1966 Corvette: Service News: Wiring Diagrams for Breakerless Ignition Systems

Subject: Wiring Diagrams for Breakerless Ignition Systems
Model and Year: 1966 Passenger Cars
Source: Chevrolet Service News
Page Number: NA
Date: November 1965 - Volume 37 - Number 10

Fig. 6-Breakerless Ignition System-Chevrolet, Chevelle & Chevy II

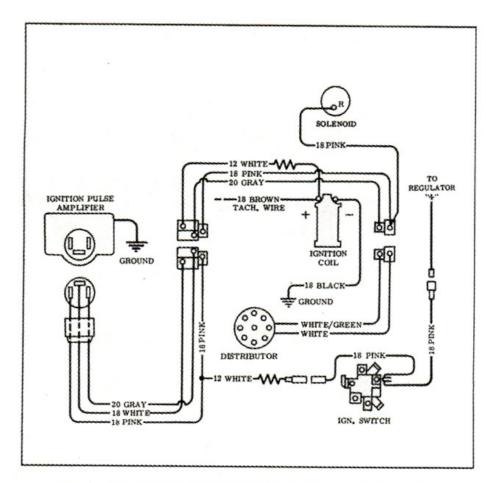
The following wiring diagrams for breakerless ignition systems superseded all other published diagrams for Chevrolet, Chevelle, Chevy II and Corvette.

The "12 white" is a calibrated resistance wire located on the negative side of the ignition coil on 1965 vehicles. However, in 1966 this resistance is placed on the positive side of the coil for added protection of the ignition pulse amplifier in case of accidentally grounding the ignition coil wire. At the present time, the above does not apply to trucks.
